February 9, 2001

HSA-10/B80

In Mr. David Hubbell's January 30 letter to Mr. Richard Powers of my staff, he requested acceptance of a fabricated tubular steel post as a direct replacement for the W150 x 13.5 wide flange posts currently used with the G4(1S) guardrail system. Under separate cover, Mr. Powers also received a copy of the Texas Transportation Institute's January 2001 report entitled "NCHRP REPORT 350 TEST 3-11 OF THE G4 W-BEAM GUARDRAIL SYSTEM WITH CENTRAL FABRICATORS, INC. STEEL POST AND PLASTIC BLOCKOUT," a copy of the crash test video tape, and material certifications for the steel used to make your posts.

Figure 1. Details of guardrail installation with Central Fabricators, Inc. posts and blockouts.

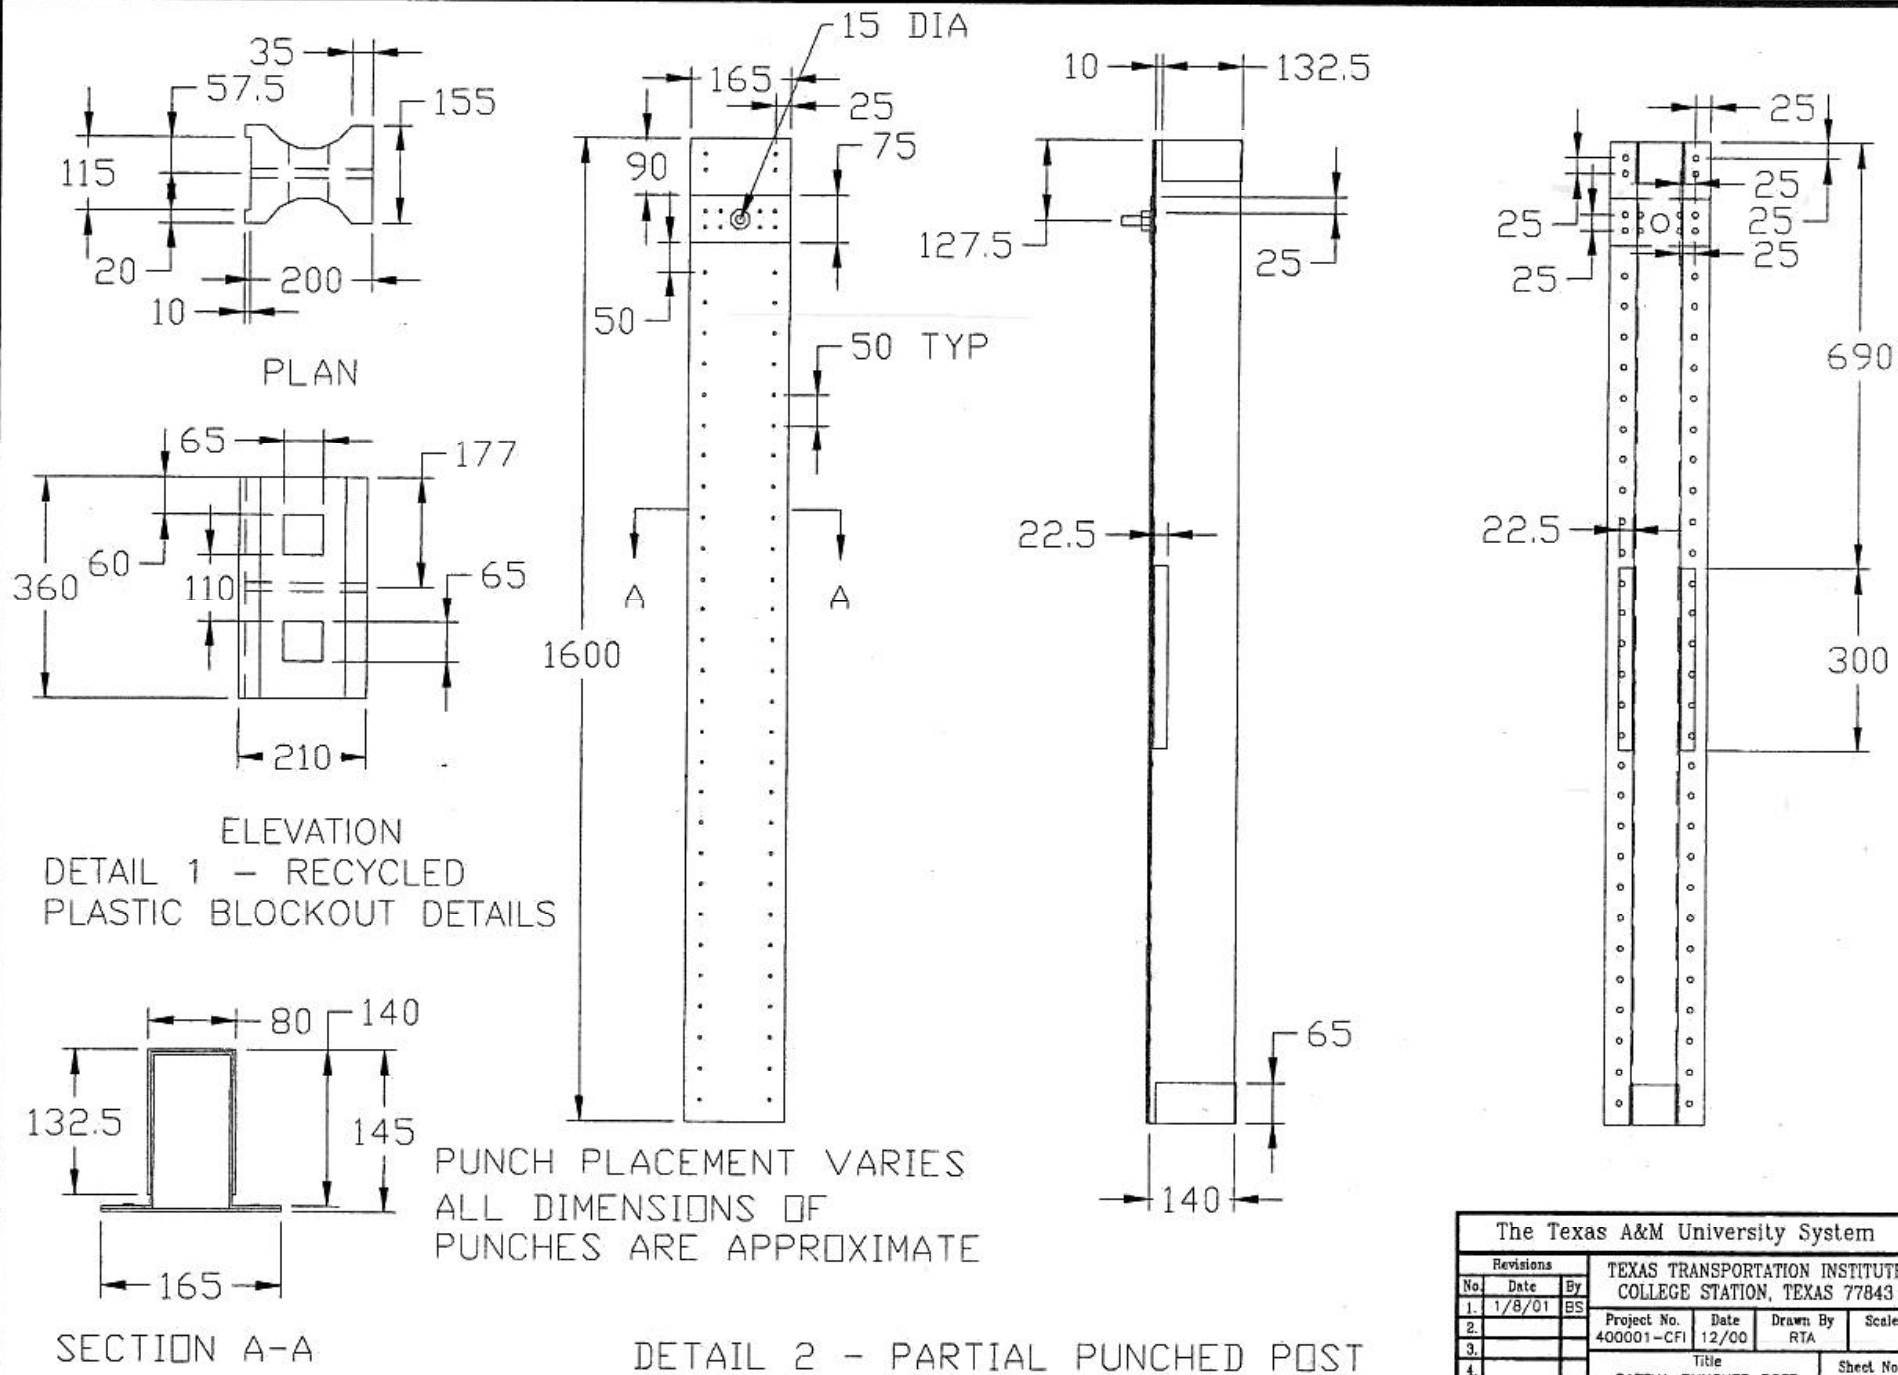
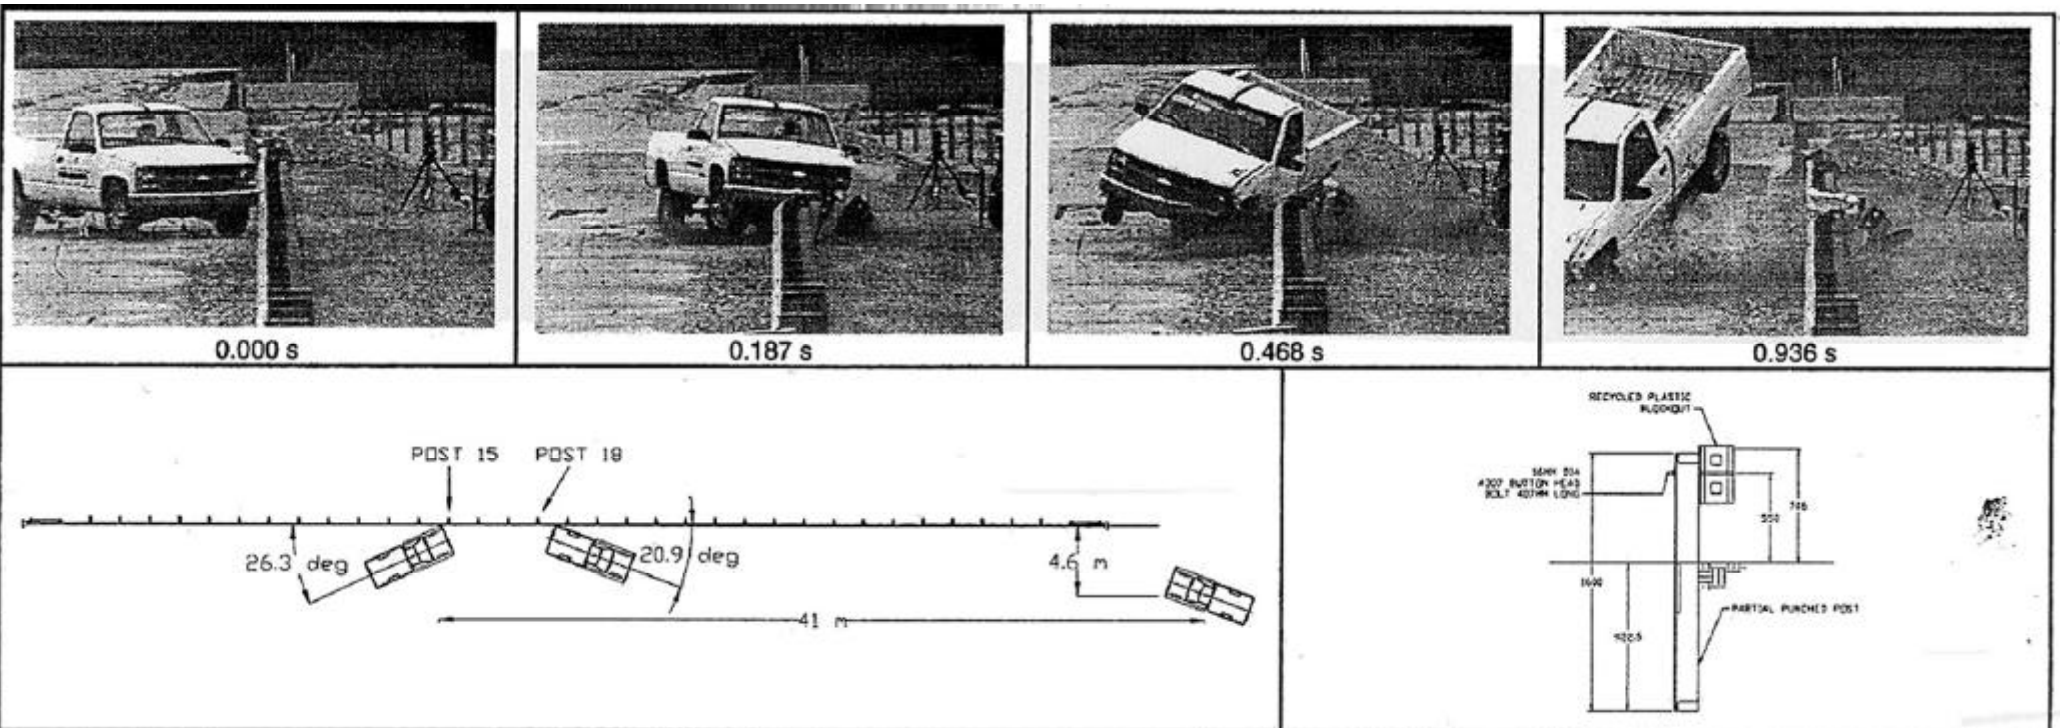
The tested posts, designated as X-48 Posts, were fabricated from 12-gauge steel plate into a rectangular cross-section with a back flange 165-mm wide, a traffic face 80-mm wide and a depth of 140 mm. The posts were comprised of several pieces of steel plate fastened together using a "partial punch" technology. Each post was 1600-mm long, spaced on 1.9-m centers, and embedded approximately 922.5 mm below grade in an NCHRP Report 350 standard soil. The 12-gauge w-beam rail was offset from the posts with 155 mm x 200 mm x 360 mm Central Fabricator's recycled plastic blocks. These blocks were installed to extend approximately 50 mm above the top of each X-48 post, thus centering the w-beam rail 550 mm above the ground. Post and offset block dimensions are shown in Enclosure 1.

Based on the information you provided, I agree that the HALCO X-48 guardrail post with the Central Fabricators' recycled plastic offset block may be considered acceptable for use on the National Highway System as a substitute for the steel post and routed wood or plastic offset blocks currently used in the G4(1S) barrier system when such use is requested by the contracting highway agency. Please note that this acceptance is only for the use of these posts in the barrier proper. They cannot be used in guardrail terminals unless specifically tested for that application.
